From: David Pickford [REDACTED]
Sent: 28 August 2019 15:32
To: Anita Gardner <Anita.Gardner@arun.gov.uk>
Subject: RE: 22 Beach Road, Littlehampton.

Following on from your attached email, for reference, please see email below from Scott Castle of Acoustic Associates (who produced the Noise Report submitted with applications LU/193/19/DOC & LU/194/19/DOC) to Carol Reynolds in response to comments made by Environmental Health.

I write further to the client providing me with your feedback on the AASL acoustic report dated 6th June 2019 for the above site.

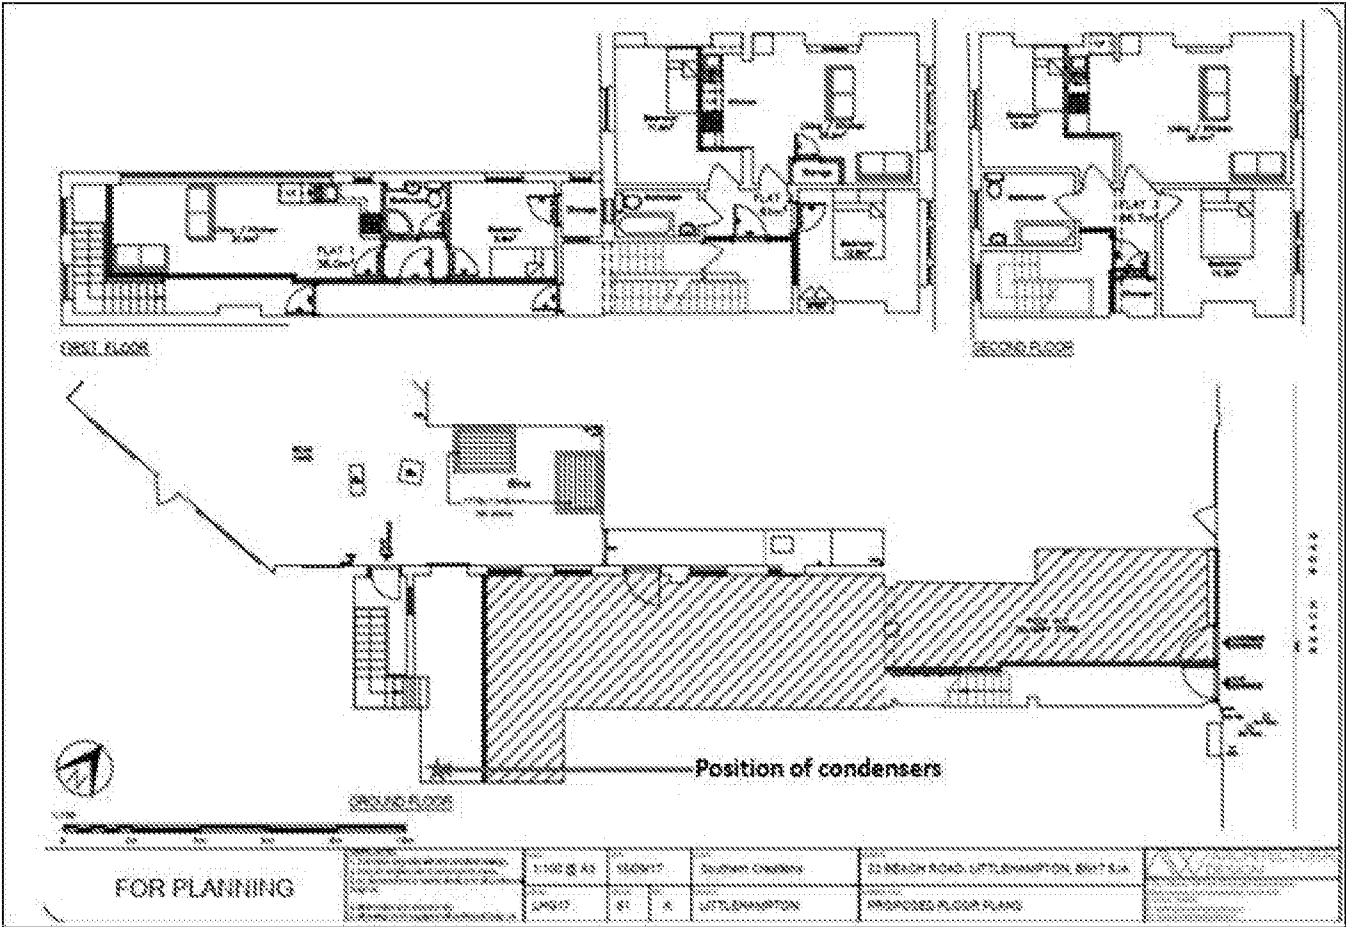
1. The condenser unit for the Walk in chiller.

The condensers were previously located below the bedroom window but have since been relocated to inside the rear garage unit at the very rear of Flat 1, outside the demise of the flat.

The condensers are mounted on anti-vibration mounts on the ground floor. Both the garage and the pizza hut ceiling were soundproofed at the same time. The condenser positions inside the garage void are shown below.

The condensers would have run as part of the survey and are contained with the survey data.
